Environmental Re-evaluation

ENVIRONMENTAL
IMPACT STATEMENT

Subject: Mountain View Corridor, Salt Lake County and Utah County Final Environmental Impact Statement and Final Section 4(f) Evaluation dated September 2008; Record of Decision dated November 17, 2008

Re: Mountain View Corridor Environmental Re-evaluation #2
UDOT Project Number *SP-0067(3)0

Figure A-03

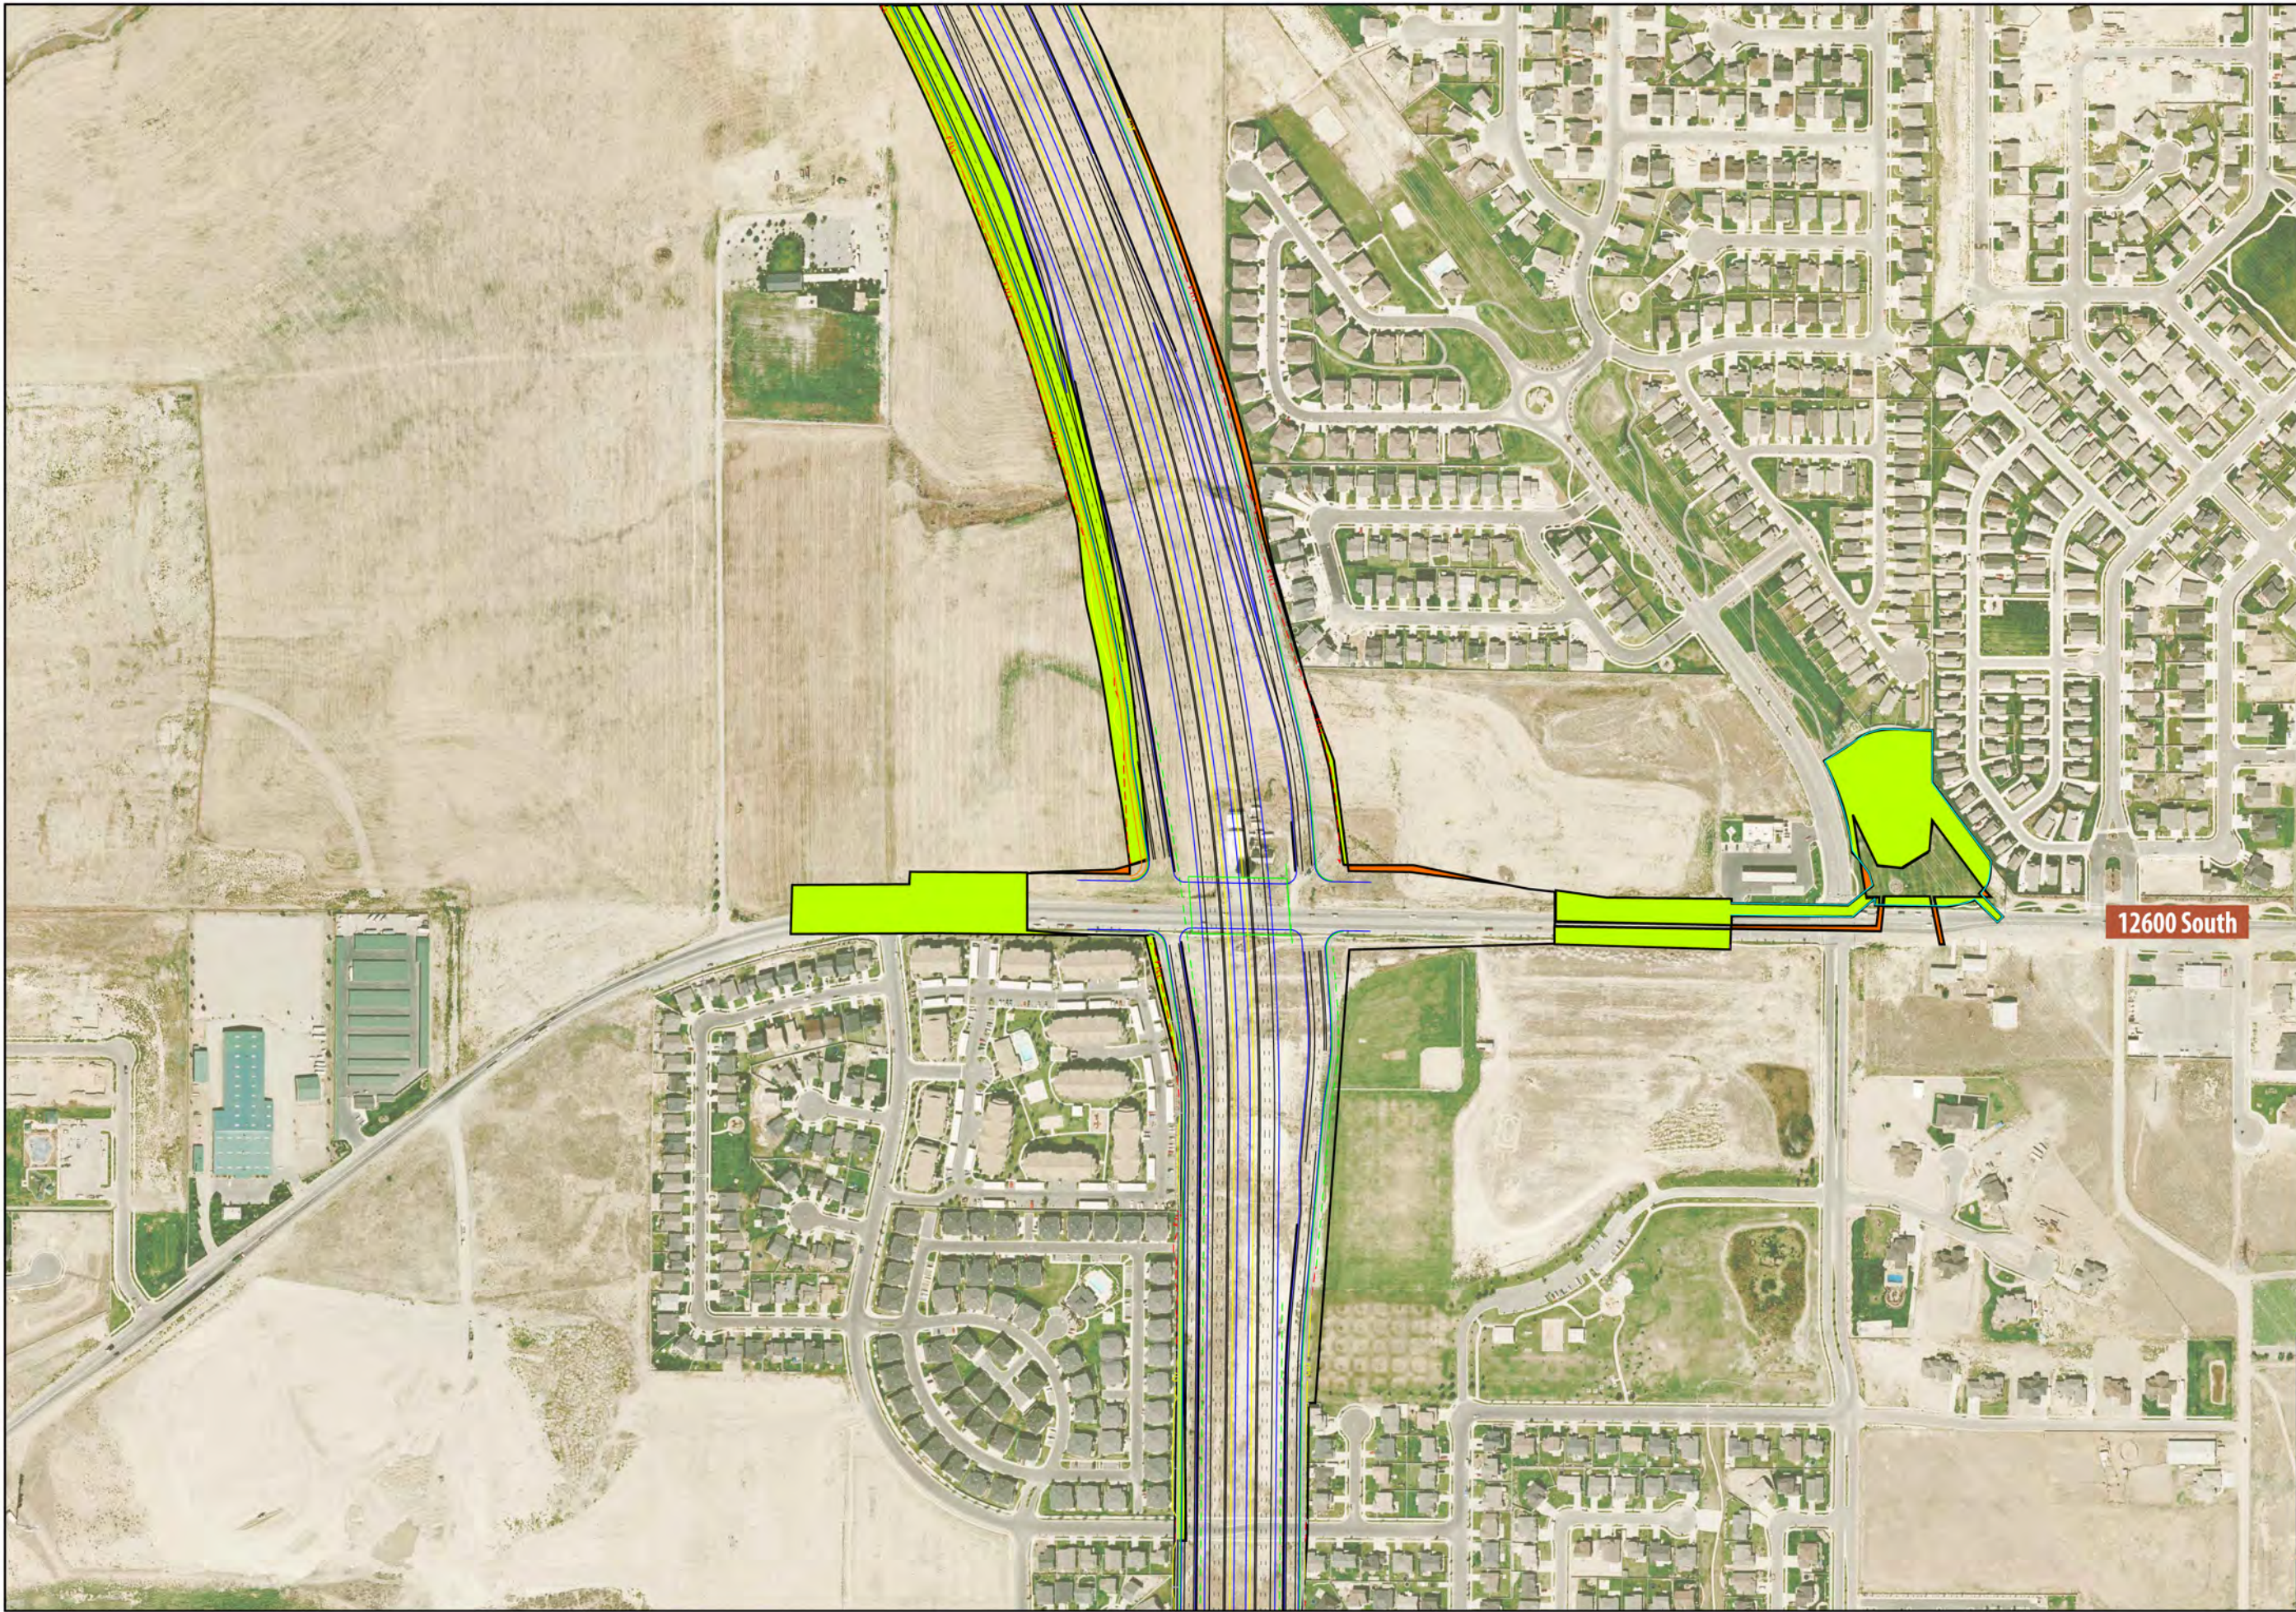
- 13400 South
 - To provide a connection to the local road system at 13400 South, the four traffic lanes with turn lanes analyzed in the Final EIS would need to be extended an additional 575 feet on the west side and 625 feet on the east side of the MVC along the cross street. To provide a connection to Herriman City's planned 13200 South street, the ramps to and from the north at 13400 South would need to be shifted north of 13200 South (see Appendix A, Figure A-03).

Figure A-04

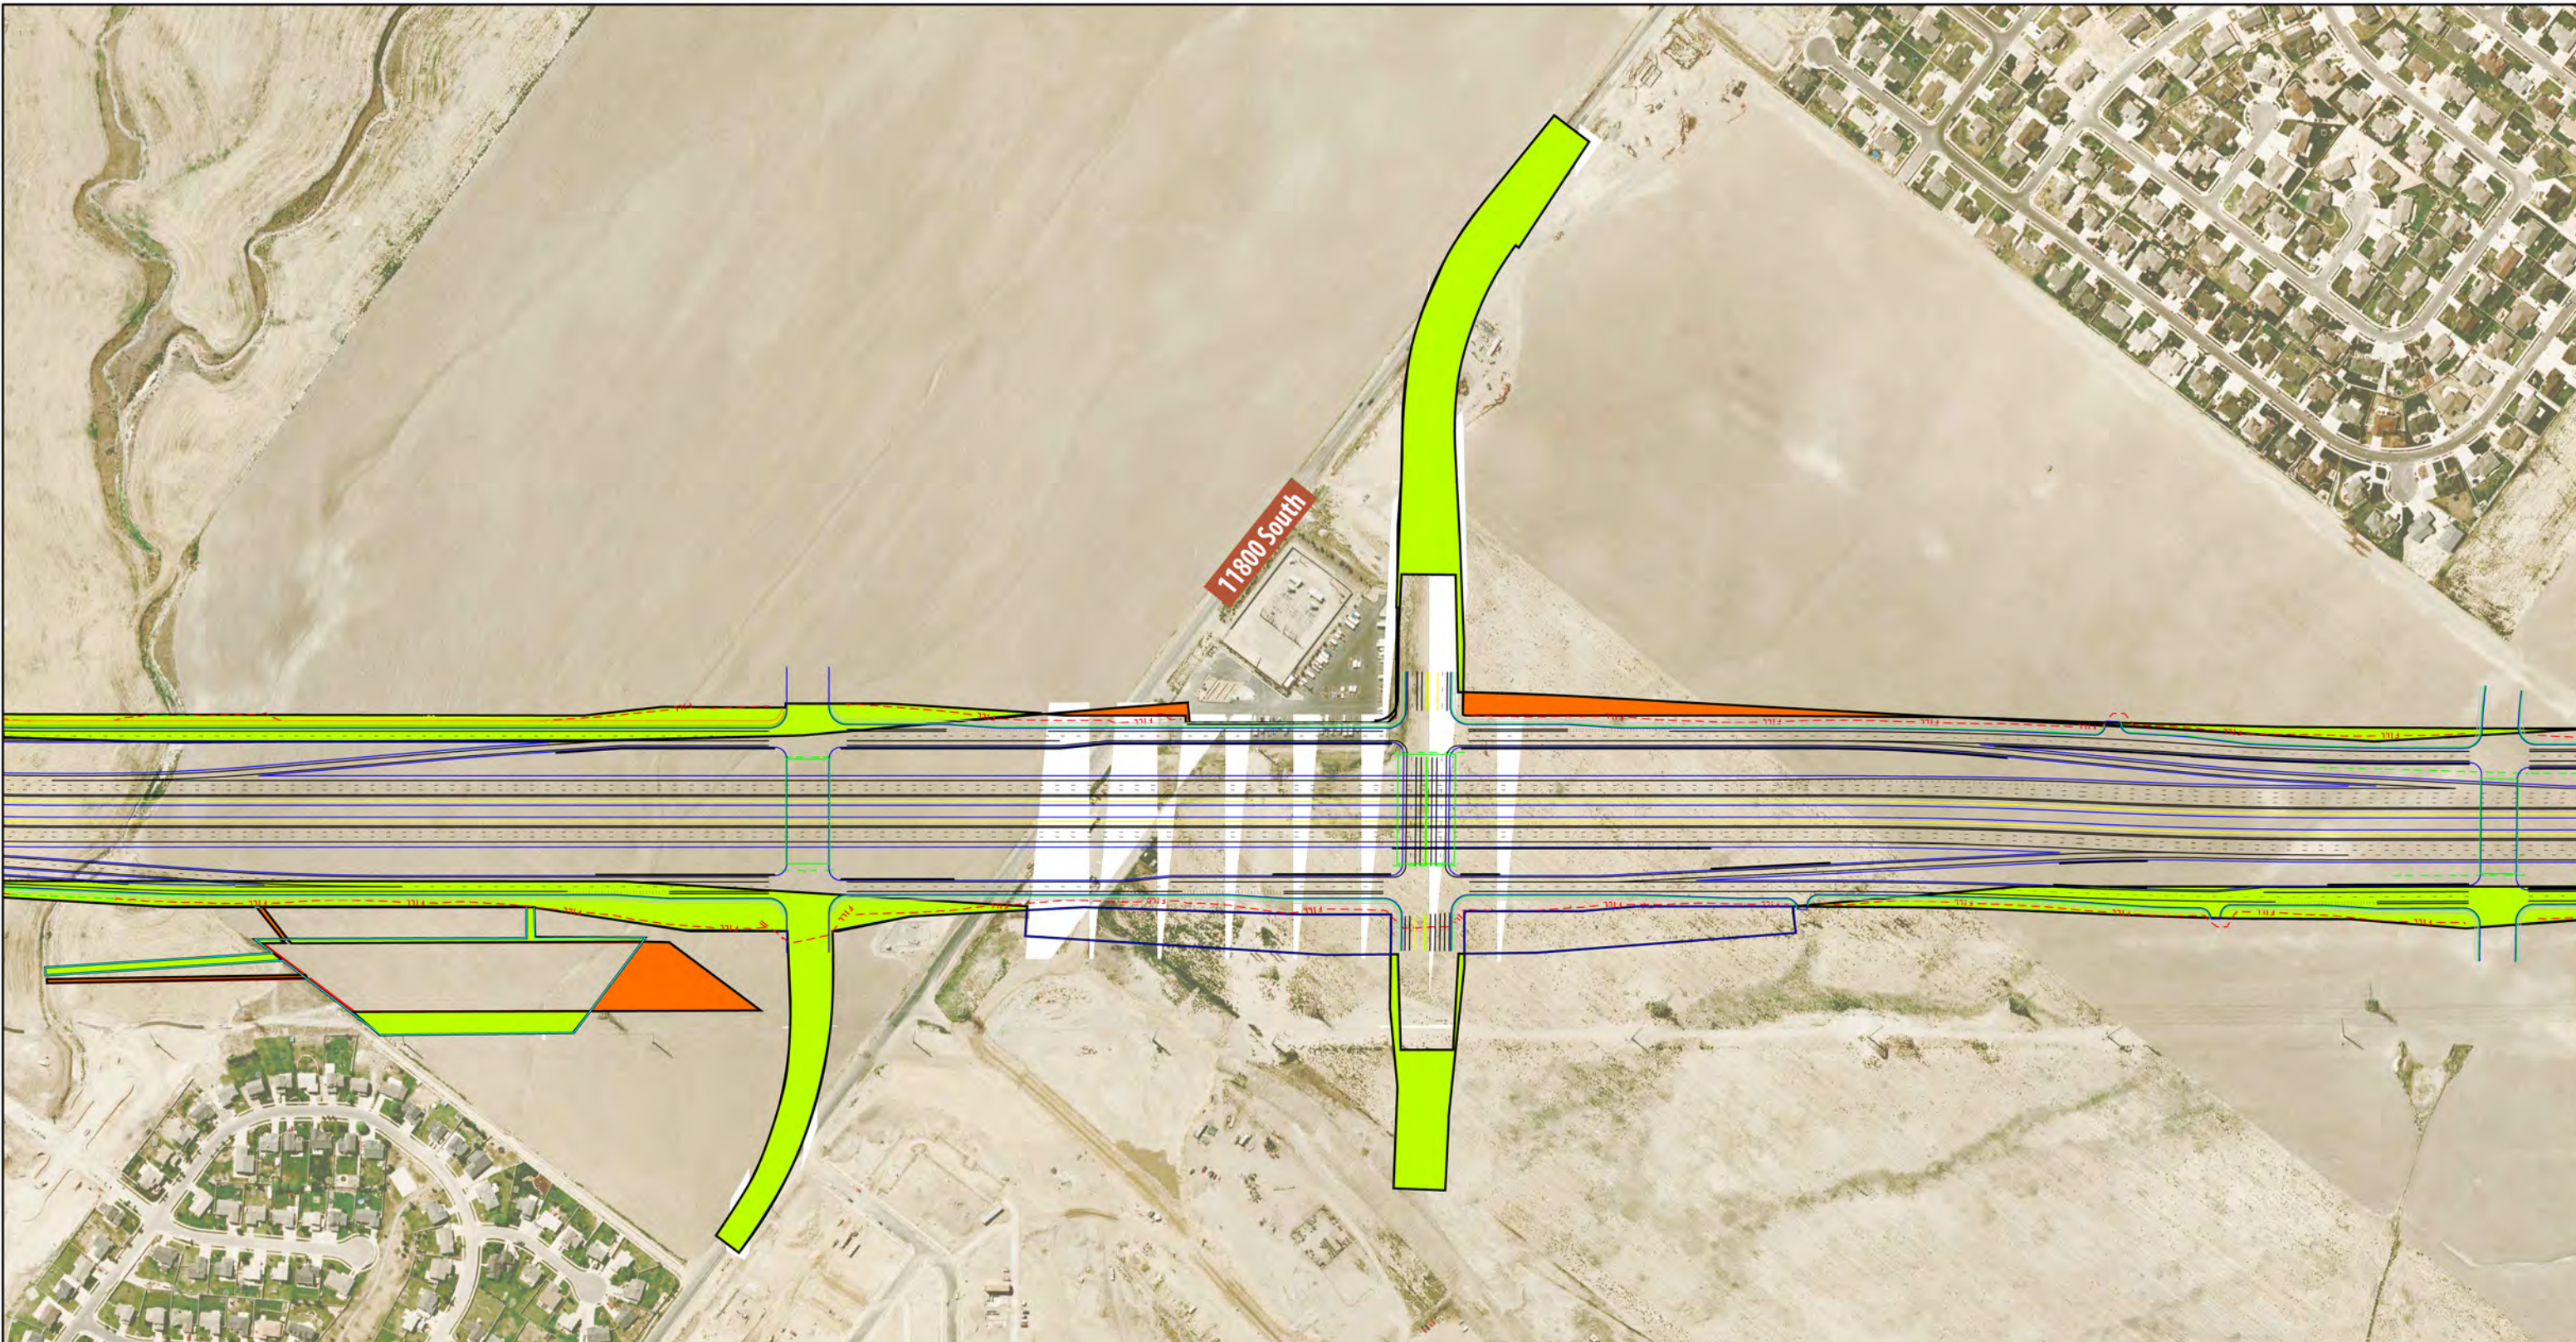
- 12600 South
 - To provide a connection to the MVC at 12600 South, the four traffic lanes with turn lanes analyzed in the Final EIS would need to be extended an additional 600 feet on the west and 450 feet on the east. Due to the addition of the frontage roads, there is not enough right-of-way width to provide a full interchange at 12600 South. Because the right-of-way is limited, there would be no northbound off ramp or southbound on ramp at 12600 South (see Appendix A, Figure A-04).

Figure A-05

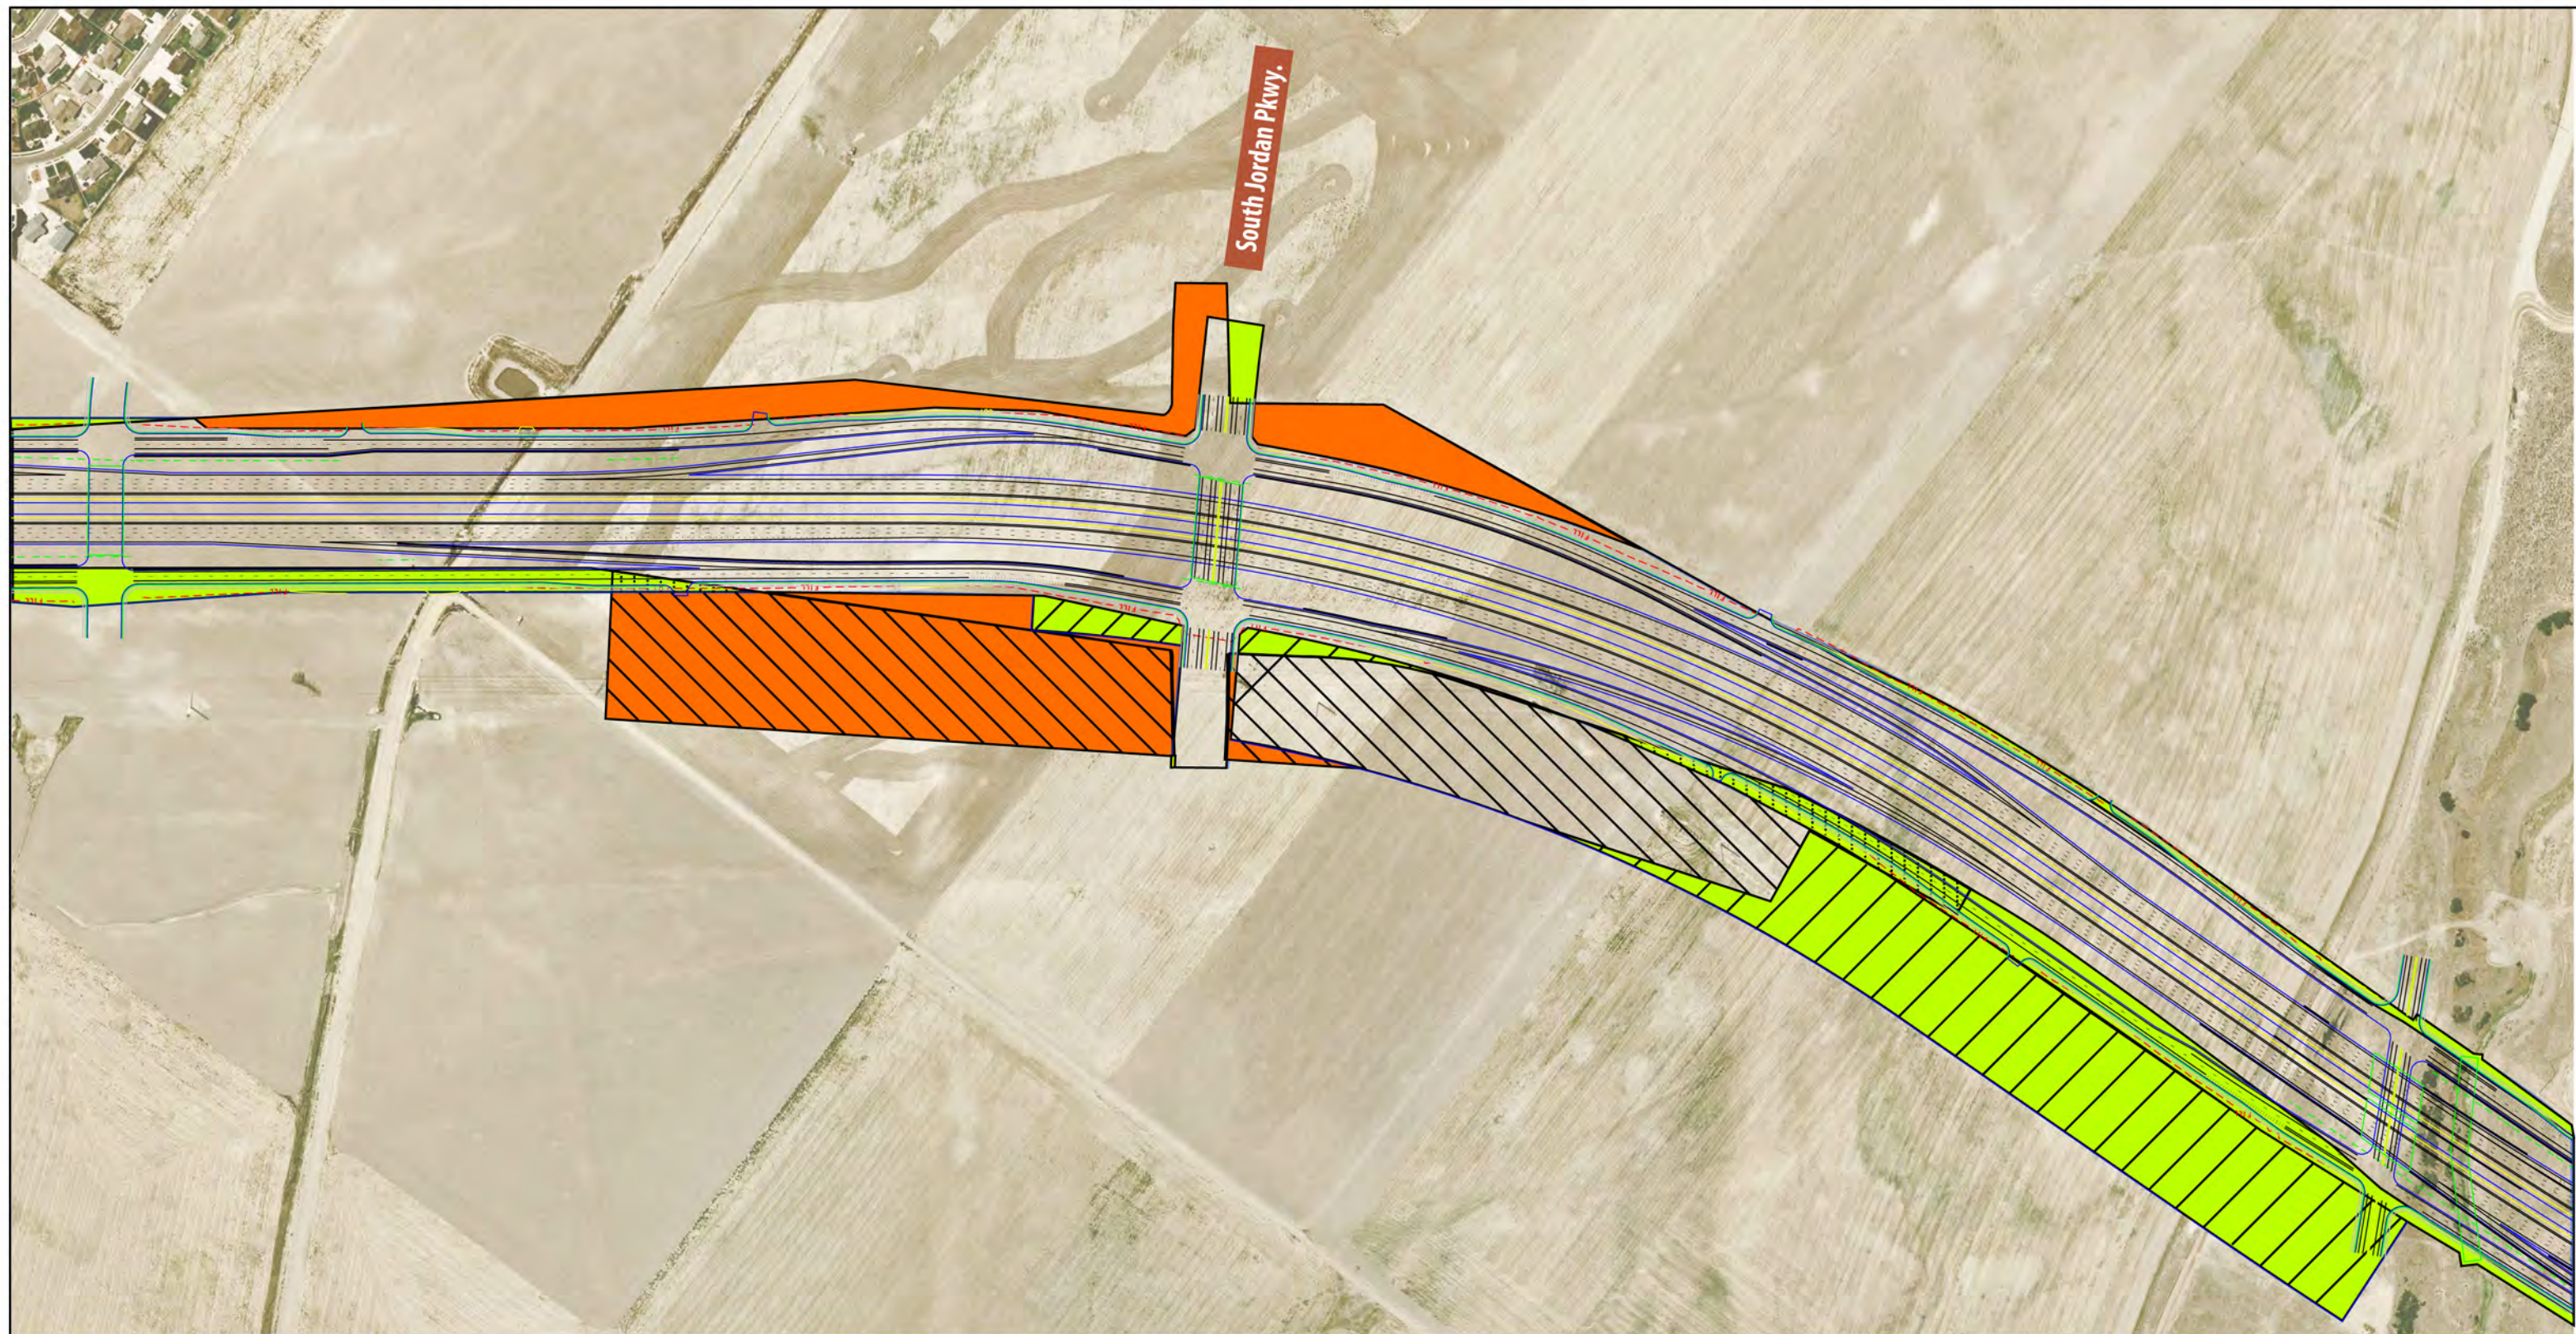
- 11800 South
 - The Final EIS did not evaluate a connection of the MVC to 11800 South. Construction of frontage roads would allow this connection, but the addition of a connection would constrain movement between the Daybreak Parkway ramps to and from the south and 11800 South. To address this constraint, the diamond interchange at Daybreak Parkway must be modified to create a split diamond interchange with movement to and from the south connecting to 11800 South (see Appendix A, Figure A-05).

- Daybreak Parkway
 - To provide a connection at Daybreak Parkway–MVC, the four traffic lanes with turn lanes analyzed in the Final EIS would need to be extended an additional 1,250 feet on the west and 350 feet on the east. The ramp movements to and from the south would also need to be shifted to the south to connect to 11800 South (see Appendix A, Figure A-05).
